# Access Audit Site Report

## Lake Somerville State Park & Trailway

Accessibility Evaluation

Inspection Date: 08/24/2021

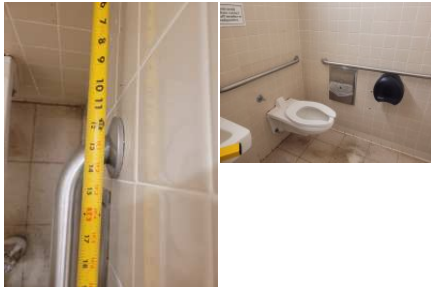
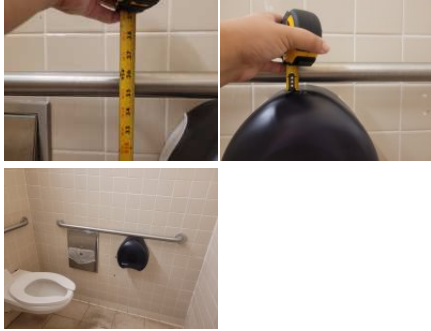
Finding Number	Area Description	Lat/Long	Finding	As Built	Recommendation	Citation	Photos	Figure
9	Nails Creek - Headquarters: (N C)Headquarters-Men's Restroom	[30.2907184 , -96.6672245]	The restroom sign does not comply with one or more applicable requirements for the location, height, and properties of the sign.	Restroom sign at 62" aff	Remount signage on wall, latch side of the door, 48" to baseline of lowest character and 60" to baseline of highest character	2015 ABAAS Section: F216.2, 703.1, 703.2, 703.5, 703.6  2012 TAS Section: 216.2, 703.1, 703.2, 703.5, 703.6  2010 ADAS Section: 216.2, 703.1, 703.2, 703.5, 703.6		
10	Nails Creek - Headquarters: (N C)Headquarters-Men's Restroom	[30.2907092 , -96.6672138]	The mirror is mounted too high. Mirrors must have the bottom edge of the reflecting surface a maximum of 40 inches above the floor if above a sink or counter. Mirrors not located above lavatories or countertops shall be installed with the bottom edge of the reflecting surface 35 inches maximum above the finish floor or ground.	Bottom edge of mirror is 41" aff	Lower mirror so reflective surface is max 40" aff	2015 ABAAS Section: 603.3  2012 TAS Section: 603.3  2010 ADAS Section: 603.3

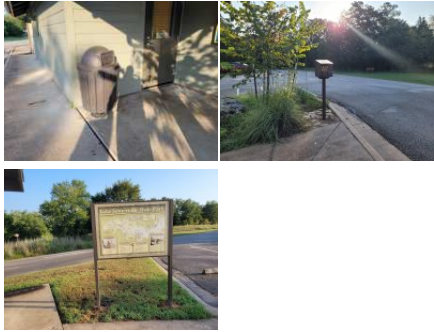
28	Nails Creek - Headquarters: (NC)Headquarters - Parking	[30.2907682 , -96.667067 6]	The accessible parking stall is not wide enough. Each parking space must be at least 8' feet wide and shall be marked to define the width. The measurements of parking spaces and access aisles shall be made from the centerline of the markings. Where the parking space is not adjacent to another parking space or access aisle, the measurement shall be permitted to include the full width of the line defining the parking space.	stall 88" wide, access aisle is 108" wide (room to repaint stall)	Repaint stalls to be 8' wide each	2015 ABAAS Section: 502.2 2012 TAS Section: 502.2 2010 ADAS Section: 502.2

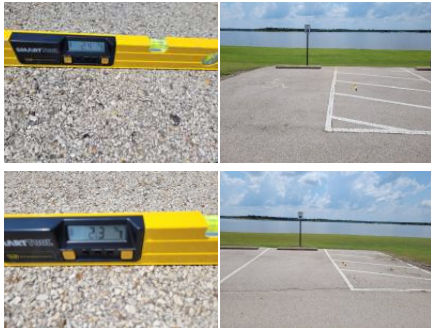
31	Nails Creek - Headquarters: (NC)Headquarters - Parking	[30.2907868 , -96.6670918]	The parking sign is mounted too low. Parking space identification signs shall include the International Symbol of Accessibility complying with. Signs identifying van parking spaces shall contain the designation "van accessible." Signs shall be 60 inches minimum above the finish floor or ground surface measured to the bottom of the sign.	The parking sign is mounted too low (53" above ground level) and located at corner of access aisle furthest from stall	Raise existing accessible parking signs so lowest end of bottom sign is min 60" aff and install it at the head of the stall	2015 ABAAS Section: 502.6 2012 TAS Section: 502.6 2010 ADAS Section: 502.6

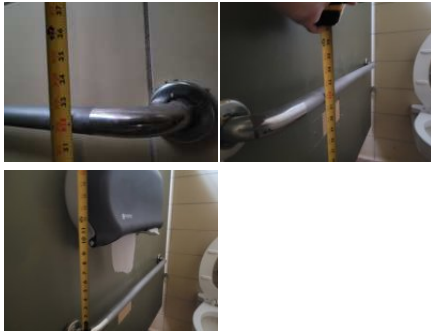
78	Nails Creek - Bent Tree Camping Area: (NC) Bent Tree-Women's Restroom	[30.2900329 , -96.664483 3]	The restroom sign does not comply with one or more applicable requirements for the location, height, and properties of the sign.	Lacks sign adjacent to door	Remount signage on wall, latch side of the door, 48" to baseline of lowest character and 60" to baseline of highest character	2015 ABAAS Section: F216.2, 703.1, 703.2, 703.5, 703.6  2012 TAS Section: 216.2, 703.1, 703.2, 703.5, 703.6  2010 ADAS Section: 216.2, 703.1, 703.2, 703.5, 703.6

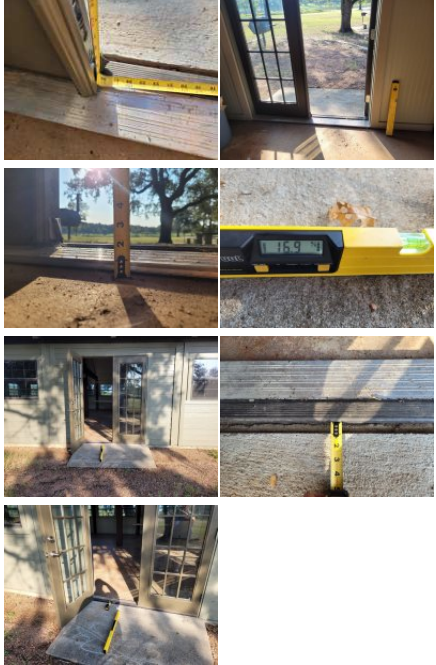
151	Nails Creek - Amenities: (NC) Nails Creek Spur-Pavilion	[30.2923883, -96.6650278]	There are no accessible parking stalls. Each lot where parking is provided for the public as clients, guests or employees, shall provide accessible parking and shall be located on the shortest accessible route of travel from adjacent parking to an accessible entrance. There are a total of 29 parking stalls in the parking lot that could be reasonably associated with this facility. There should be a minimum of 2 accessible stalls with a minimum of 1 being designed as van accessible.	Lacks required number of accessible parking stalls (28 standard, 1 accessible)	Create one or more 8' accessible parking stalls, with one 5' adjacent access aisle, with proper signage and striping based on the total number of stalls	2015 ABAAS Section: F208.2  2012 TAS Section: 208.2  2010 ADAS Section: 208.2

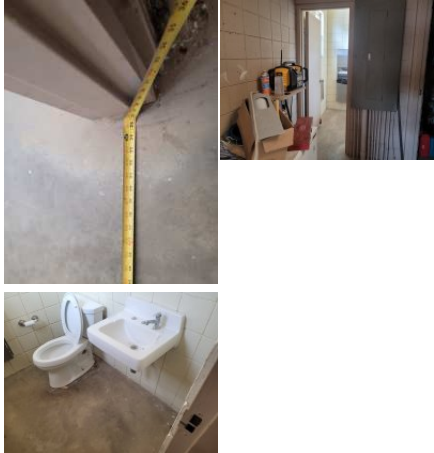
164	Nails Creek - Amenities: (NC) Group Pavilion At Boat Ramp	[30.2952763 , -96.665031 8]	The cross slopes (narrow dimension) and/or running slopes (long dimension) of the access aisle exceeds 2%. The running slope and the cross slope in an accessible parking stall and the access aisle must not exceed 2%.	Slopes of 4.6% in access aisle and 5.7% in stall	Repair or correct slope of parking space and access aisle to max 2.08% in any direction	2015 ABAAS Section: 502.4  2012 TAS Section: 502.4  2010 ADAS Section: 502.4

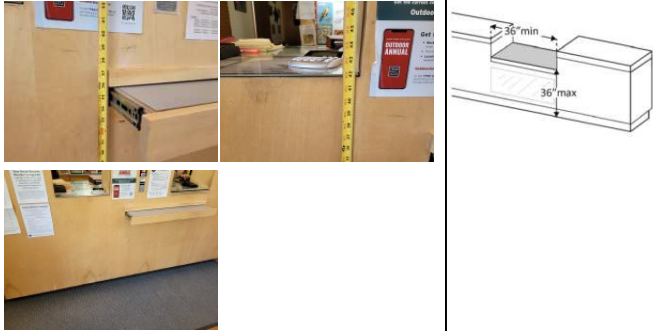
178	Birch Creek - Headquarters: (BC) Headquarters-Employee Areas	[30.3086035, -96.6347054]	The restroom sign does not comply with one or more applicable requirements for the location, height, and properties of the sign.	staff restroom lacks compliant signage	Acquire and mount signage, including Braille and access symbol mounted on wall, latch side of door, 48" to baseline of lowest character and 60" to baseline of highest character	2015 ABAAS Section: F216.2, 703.1, 703.2, 703.5, 703.6  2012 TAS Section: 216.2, 703.1, 703.2, 703.5, 703.6  2010 ADAS Section: 216.2, 703.1, 703.2, 703.5, 703.6		
179	Birch Creek - Headquarters: (BC) Headquarters-Employee Areas	[30.3085965, -96.6347001]	The mirror is mounted too high. Mirrors must have the bottom edge of the reflecting surface a maximum of 40 inches above the floor if above a sink or counter. Mirrors not located above lavatories or countertops shall be installed with the bottom edge of the reflecting surface 35 inches maximum above the finish floor or ground.	staff restroom mirror 40.25"	Lower mirror so reflective surface is max 40" aff	2015 ABAAS Section: 603.3  2012 TAS Section: 603.3  2010 ADAS Section: 603.3

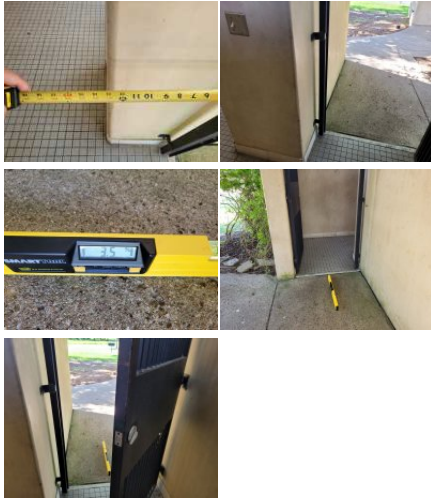
Finding Number	Area Description	Lat/Long	Finding	As Built	Recommendation	Citation	Photos	Figure
180	Birch Creek - Headquarters: (BC) Headquarters-Employee Areas	[30.3086104 , -96.6347028]	Knee clearance at 27 inches off the floor is not 8 inches minimum deep. The knee clearance, measured from the bottom of the apron or the outside bottom edge of the lavatory, must be 27 inches at a point located 8 inches back from the front edge and continuing to 11 inches minimum in depth at 9 inches above the floor. The top of the lavatory rim may be no higher than 34 inches.	staff restroom- sink lacks 8" deep knee clearance due to storage	Relocate storage to provide 8" deep knee clearance	2015 ABAAS Section: 306.3.1, 306.3.2, 306.3.3, 306.3.4 , 306.3.5  2012 TAS Section: 306.3.2, 306.3.3, 306.3.4, 306.3.5, 306.3.1  2010 ADAS Section: 306.3.3, 306.3.2, 306.3.4, 306.3.5, 306.3.1		
181	Birch Creek - Headquarters: (BC) Headquarters-Employee Areas	[30.3085965 , -96.6347162]	The operable part is positioned too high for either a side or front approach. Where a clear floor or ground space allows a parallel approach to an element and the side reach is unobstructed, the high side reach shall be 48 inches maximum and the low side reach shall be 15 inches minimum above the finish floor or ground. Where a forward reach is unobstructed, the high forward reach shall be 48 inches maximum and the low forward reach shall be 15 inches minimum above the finish floor or ground.	staff restroom- paper towels exceed reach range	Remount operable parts to be in reach range of 15" min to 48" max	2015 ABAAS Section: 308.1  2012 TAS Section: 308.1  2010 ADAS Section: 308.1

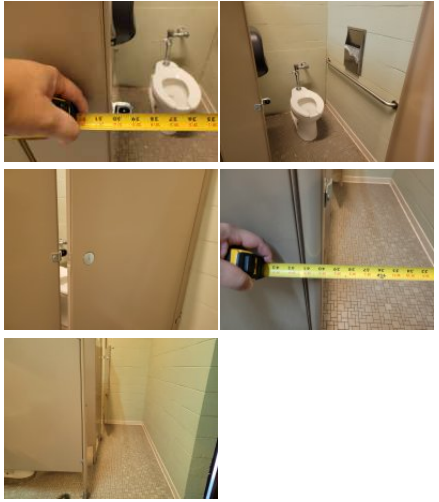
235	Birch Creek - Old Hickory Camping Area: (BC) Old Hickory Restrooms 1 - Men's Restroom	[30.3070323 , -96.637161]	The restroom sign does not comply with one or more applicable requirements for the location, height, and properties of the sign.	Lacks compliant signage	Acquire and mount signage, including Braille and access symbol mounted on wall, latch side of door, 48" to baseline of lowest character and 60" to baseline of highest character	2015 ABAAS Section: F216.2, 703.1, 703.2, 703.5, 703.6 2012 TAS Section: 216.2, 703.1, 703.2, 703.5, 703.6 2010 ADAS Section: 216.2, 703.1, 703.2, 703.5, 703.6

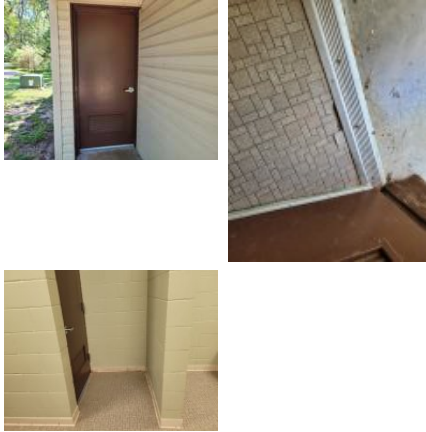
260	Birch Creek - Old Hickory Camping Area: (BC) Old Hickory Restrooms 2 - Men's Restroom	[30.3054496 , -96.6381977]	The water and drain pipes under the lavatory are not adequately insulated. Water supply and drain pipes under lavatories and sinks shall be insulated or otherwise configured to protect against contact. There shall be no sharp or abrasive surfaces under lavatories and sinks.	Sink lacks insulated pipes	Insulate exposed pipes under one sink	2015 ABAAS Section: 606.5  2012 TAS Section: 606.5  2010 ADAS Section: 606.5

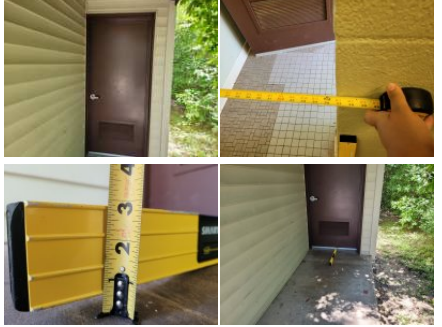
311	Birch Creek - Post Oak Camping Area: (BC) Post Oak Campsites	[30.3100843 , -96.626338 3]	Water spouts at water hydrants and water utility hook-ups shall be 28 inches (710 mm) minimum and 36 inches (915 mm) maximum above the ground	campsite 46- water spout is 25" above ground level	Remount water spouts to 28" min or 36" max above the ground as a smart practice	2015 ABAAS Section: 1011.6		
312	Birch Creek - Post Oak Camping Area: (BC) Post Oak Campsites	[30.3105451 , -96.62434]	The surface of the outdoor recreation access route, passing spaces, and/or resting intervals are not firm and stable. The surface of outdoor recreation access route, passing spaces, and resting intervals shall be firm and stable, having a width of 36", max gaps of .5" and tread obstacles of .5" or less.	campsite 57 - 1" gap	Correct or fill gaps to max .5" as a smart practice	2015 ABAAS Section: 1016.2		
313	Birch Creek - Post Oak Camping Area: (BC) Post Oak Campsites	[30.310559 , -96.624322 6]	The cross slope shall not be steeper than 1:48. EXCEPTION: Where the surface is other than concrete, asphalt, or boards, cross slopes not steeper than 1:20 shall be permitted when necessary for drainage.	campsite 57- 2.2% cross slope	Correct or repair ORAR cross slope to max 2.08% as a smart practice.	2015 ABAAS Section: 1016.7.2, 1016.7.2 EXCEPTION

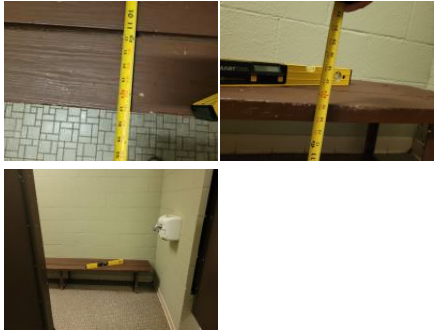
Finding Number	Area Description	Lat/Long	Finding	As Built	Recommendation	Citation	Photos	Figure
325	Birch Creek - Post Oak Camping Area: (BC) Post Oak-Men's Restroom	[30.310926, -96.625646 3]	The restroom sign does not comply with one or more applicable requirements for the location, height, and properties of the sign.	Lacks compliant signage	Acquire and mount signage, including Braille and access symbol mounted on wall, latch side of door, 48" to baseline of lowest character and 60" to baseline of highest character	2015 ABAAS Section: F216.2, 703.1, 703.2, 703.5, 703.6  2012 TAS Section: 216.2, 703.1, 703.2, 703.5, 703.6  2010 ADAS Section: 216.2, 703.1, 703.2, 703.5, 703.6		
326	Birch Creek - Post Oak Camping Area: (BC) Post Oak-Men's Restroom	[30.3109248, -96.625649]	Knee clearance at 27 inches off the floor is not 8 inches minimum deep. The knee clearance, measured from the bottom of the apron or the outside bottom edge of the lavatory, must be 27 inches at a point located 8 inches back from the front edge and continuing to 11 inches minimum in depth at 9 inches above the floor. The top of the lavatory rim may be no higher than 34 inches.	Sink lacks 8" deep knee clearance	Raise sink bowl to provide 27" knee clearance, in the alternative, acquire a shallower model	2015 ABAAS Section: 306.3.1, 306.3.2, 306.3.3, 306.3.4, 306.3.5  2012 TAS Section: 306.3.2, 306.3.3, 306.3.4, 306.3.5, 306.3.1  2010 ADAS Section: 306.3.3, 306.3.2, 306.3.4, 306.3.5, 306.3.1

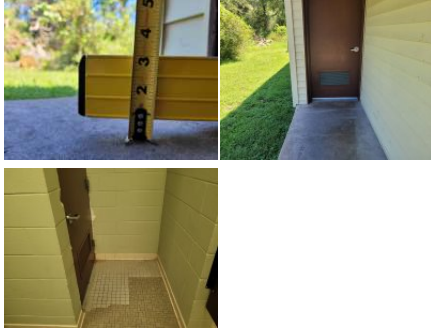
330	Birch Creek - Post Oak Camping Area: (BC) Post Oak-Men's Restroom	[30.3109121 , -96.6256369]	There are not enough accessible toilet compartments. The room contains several toilet compartments. A minimum of 1 must be wheelchair accessible .	ambulatory stall only	Create a wheelchair accessible stall with grab bars and fixtures mounted in correct locations and at correct heights	2015 ABAAS Section: F213.3.1  2012 TAS Section: 213.3.1  2010 ADAS Section: 213.3.1

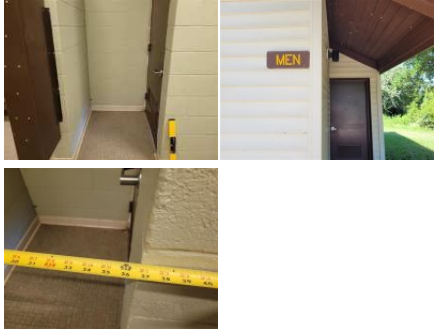
Finding Number	Area Description	Lat/Long	Finding	As Built	Recommendation	Citation	Photos	Figure
390	Birch Creek - Boat Ramp: (BC) Boat Ramp - Restrooms	[30.3096675 , -96.619753 5]	The sink is not accessible. A clear floor space at least 30 inches by 48 shall be provided in front of a sink to allow forward approach. -The clear floor space shall be on an accessible route and shall extend a maximum of 19 inches underneath the sink. -Sinks shall be mounted with the counter or rim no higher than 34 inches above the finish floor. -Knee clearance at least 27 inches high, 30 inches wide and 19 inches deep shall be provided. -Hot water and drain pipes exposed under sinks shall be insulated or otherwise configured so as to protect against contact. There shall be no sharp or abrasive surfaces under sinks. -Faucet controls not require tight grasping, pinching or twisting of the wrist. -The force required to activate controls shall be not greater than 5 lb. Lever-operated, push-type and electronically controlled mechanisms are examples of acceptable designs. -Self-closing valves are allowed if the faucet remains open for at least 10 seconds.	sink at portable toilets lacks knee and toe clearance, foot operated	Replace portable sink with one that is accessible	2015 ABAAS Section: 606.2, 606.2 EXCEPTION S: 1, 606.2 EXCEPTIONS: 4, 606.2 EXCEPTIONS: 5, 606.2 EXCEPTIONS: 6, 606.2 EXCEPTIONS: 7, 606.3, 606.4, 606.5  2012 TAS Section: 606.2, 606.2 Exception 1, 606.2 Exception 4, 606.2 Exception 5, 606.2 Exception 6, 606.2 Exception 7, 606.3, 606.4, 606.5  2010 ADAS Section: 606.2, 606.2 Exception 1, 606.2 Exception 4, 606.2 Exception 5, 606.2 Exception 6, 606.2 Exception 7, 606.3, 606.4, 606.5

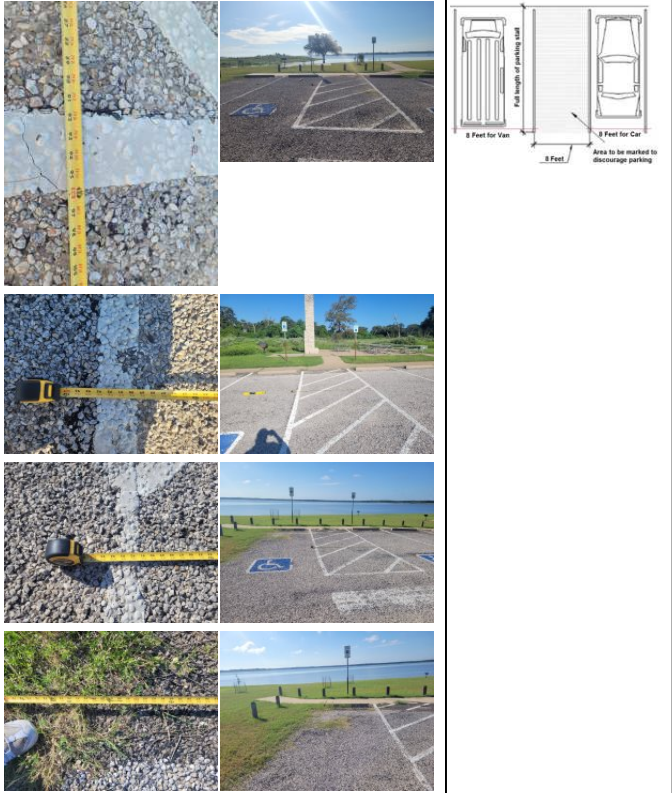
476	Birch Creek - Cedar Elm Day Use Area : (BC) Cedar Elm-Picnic Area	[30.3076078 , -96.623408]	At least one outdoor recreation access route shall connect accessible elements, spaces, and facilities provided within picnic units with mobility features	Lacks accessible route to swimming signs and water spigots	Extend an AR to features and elements in the shelter or picnic area as a smart practice.	2015 ABAAS Section: F245.4.1

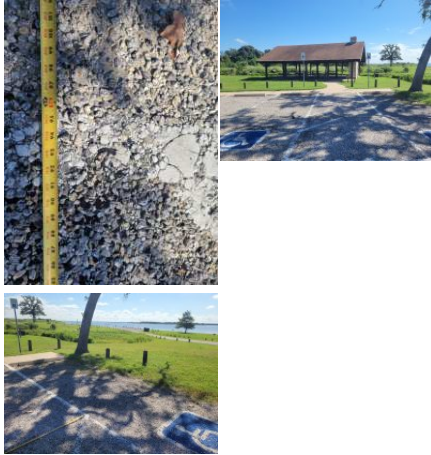
Finding Number	Area Description	Lat/Long	Finding	As Built	Recommendation	Citation	Photos	Figure
487	Birch Creek - Cedar Elm Day Use Area : (BC) Cedar Elm Picnic Parking	[30.307859, -96.620527 3], [30.3077826 , -96.620304 7]	The cross slopes (narrow dimension) and/or running slopes (long dimension) of the access aisle exceeds 2%. The running slope and the cross slope in an accessible parking stall and the access aisle must not exceed 2%.	group 1 picnic and open picnic at lake-slopes of 3.6%, 2.4%, 2.7%, 3.3%, 2.6%, 4.9%, and 2.8%	Resurface stalls and access aisles to eliminate gaps, cracks, CILs, ad slopes	2015 ABAAS Section: 502.4  2012 TAS Section: 502.4  2010 ADAS Section: 502.4
